ADDENDUM # 2

IFB #3033
Bullocks Creek VFD Building Addition

BULLOCKS CREEK
VOLUNTEER FIRE
DEPARTMENT ADDITION
2250 SC HIGHWAY 97
SHARON, SC 29742

DRIVEWAY/PARKING PAVEMENT SECTIONS

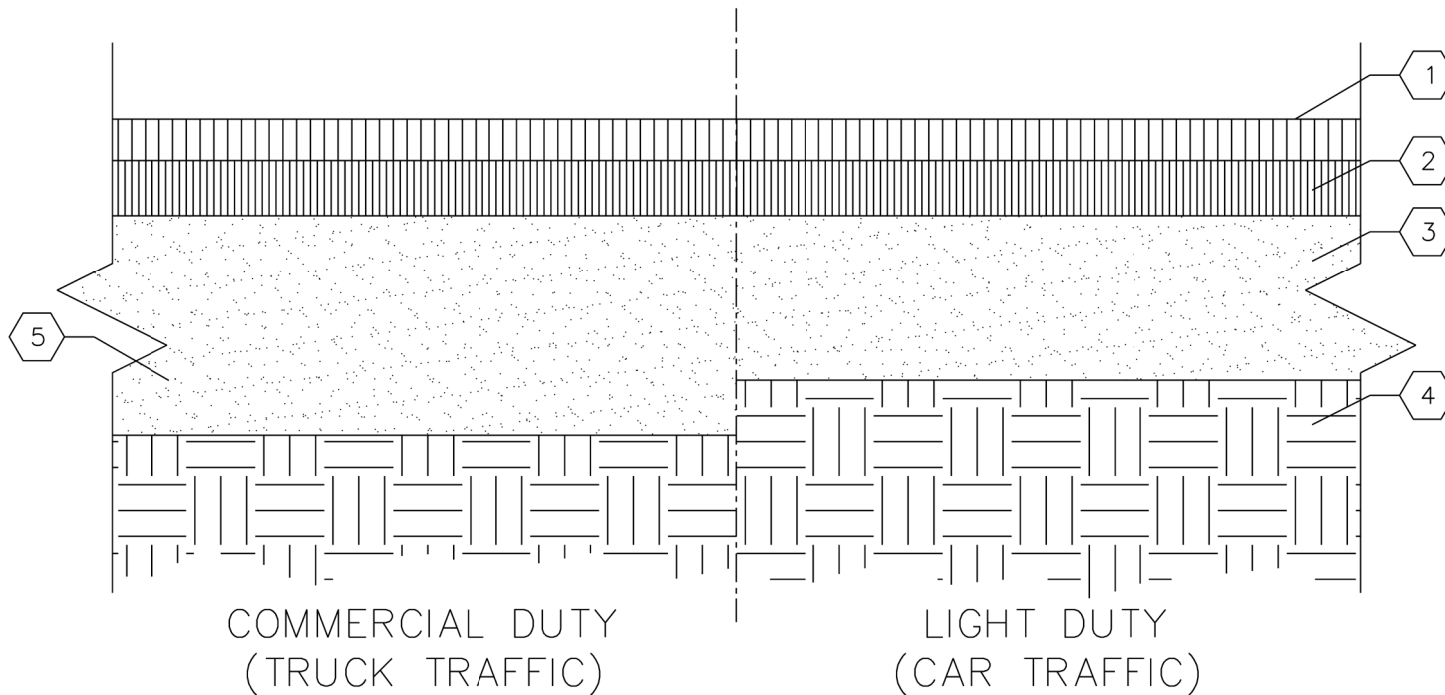
Change 1: Add Heavy Duty Asphalt Section (attached)

- 1 1 1/2" WEARING SURFACE OVER TACK COAT.
- 2 2" BINDER COURSE OVER PRIME COAT.
- 3 6" (MIN.) CLEAN, GRADED AND COMPACTED STONE (NO SLAG).
- 4 WELL-DRAINED SUB-GRADE (SUB-GRADE TO MODIFIED 95 PROCTOR MIN. COMPACTION).
- 5 8" CLEAN, GRADED & COMPACTED STONE BASE (NO SLAG).
